Product Change Notification

mPower[™] Edge Intelligence Update
mPower 6.0.1 Now Available

Date: October 3, 2022

PCN 08032022-002 (Conduit - mPower)

Models Impacted (mPower 6.0.1)

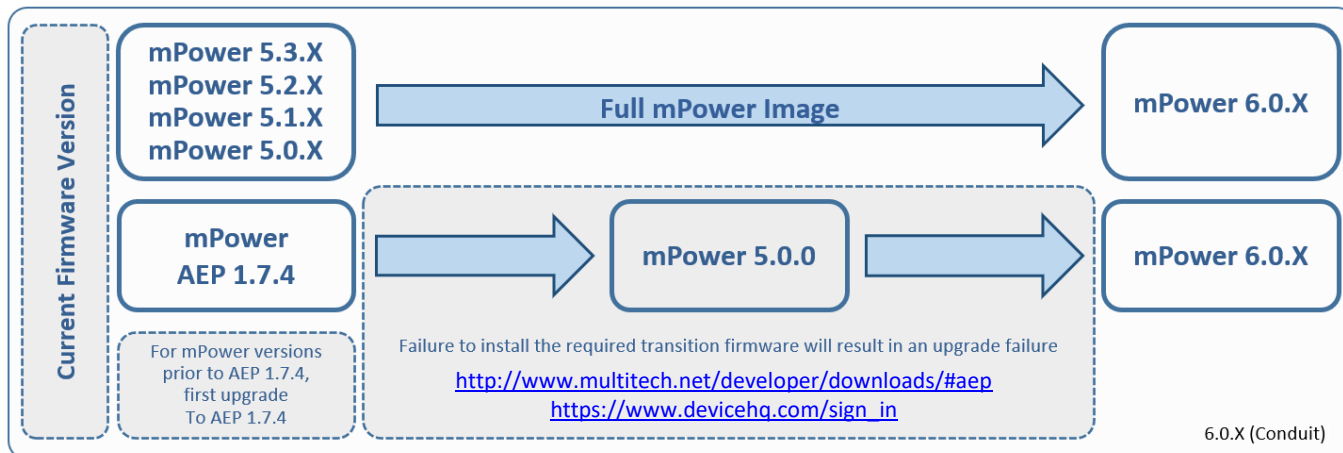
The following ordering part numbers are impacted by these updates:

- MultiTech Conduit[®] Gateway
 - MTCDT-240A, MTCDT-246A, MTCDT-247A
 - MTCDT-L4G1, MTCDT-L4E1, MTCDT-L4N1, MTCDT-LAP3, MTCDT-LAT3, MTCDT-LDC3, MTCDT-LSB3
- MultiTech Conduit[®] IP67 200 Series Base Station
 - MTCDTIP2-EN
 - MTCDTIP2-L4E1, MTCDTIP2-LNA3
- MultiTech Conduit[®] IP67 Base Station
 - MTCDTIP-266A, MTCDTIP-267A
 - MTCDTIP-L4G1, MTCDTIP-L4E1, MTCDTIP-L4N1, MTCDTIP-LAP3, MTCDTIP-LDC3, MTCDTIP-LSB3
- MultiTech Conduit[®] AP Access Point
 - MTCAP-868, MTCAP2-868, MTCAP-915, MTCAP2-915
 - MTCAP-L4E1, MTCAP2-L4E1, MTCAP-LNA3, MTCAP2-LNA3
